Access Compliance Report

Public Rights-of-Way

Intersection ID: 52627	Main Street: PICASSO TERRACE LN	Cross Street: CORMWELL LN	Location: NW
ADA ID: 263AB2031A78	Ramp Type: Perp	Initial Pass/Fail: Fail	Overall Compliance: No
		Severity Score: 12.5

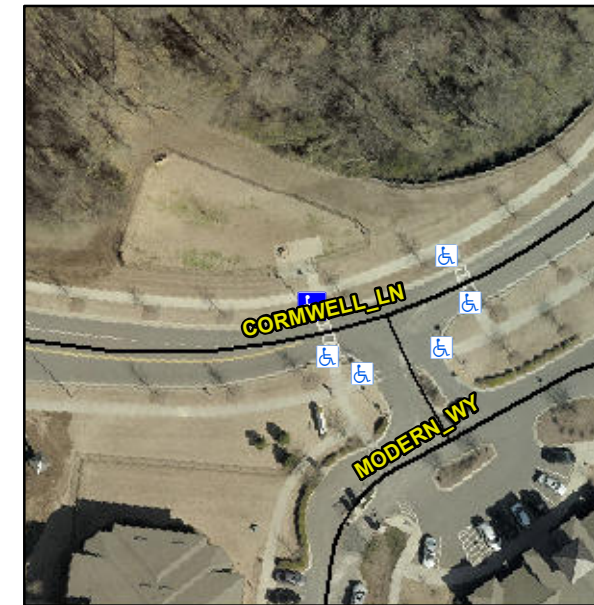
Not Found, R304.2.2

Compliance	Description	Data	Compliance	Description	Data
N/A	Ramp Length (in)	92.0	No	Ramp Slope (%)	8.4
Yes	Ramp Width (in)	58.0	Yes	Ramp XSlope (%)	0.6
N/A	Flare Type LT	N/A	N/A	Flare Type RT	N/A
N/A	Flare Slope LT (%)	N/A	N/A	Flare Slope RT (%)	N/A
N/A	Flare Traversable LT?	N/A	N/A	Flare Traversable RT?	N/A
N/A	Landing Length (in)	N/A	N/A	DWS Provided?	N/A
N/A	Landing Width (in)	N/A	N/A	DWS Contrast?	N/A
N/A	Landing Slope (%)	N/A	N/A	DWS Length (in)	N/A
N/A	Landing X Slope (%)	N/A	N/A	DWS Full Width?	N/A
N/A	Landing Curb? (Y/N)	N/A	N/A	DWS Offset (in)	N/A
N/A	Shared Landing?	N/A			
N/A	Gutter Ponding?	N/A	N/A	Gutter Slope (%)	N/A
N/A	Gutter Lip Ht (in)	N/A	N/A	Gutter X Slope (%)	N/A
N/A	Painted X Walk1?	Yes	N/A	Painted X Walk2?	N/A
	X Walk 1 Direction	To S		X Walk 2 Direction	N/A
N/A	X Walk 1 Width (in)	61.0	N/A	X Walk 2 Width (in)	N/A
	X Walk 1 Slope (%)	1.0		X Walk 2 Slope (%)	N/A
	X Walk 1 X Slope (%)	1.5		X Walk 2 X Slope (%)	N/A

Remove & Replace Entire Ramp.
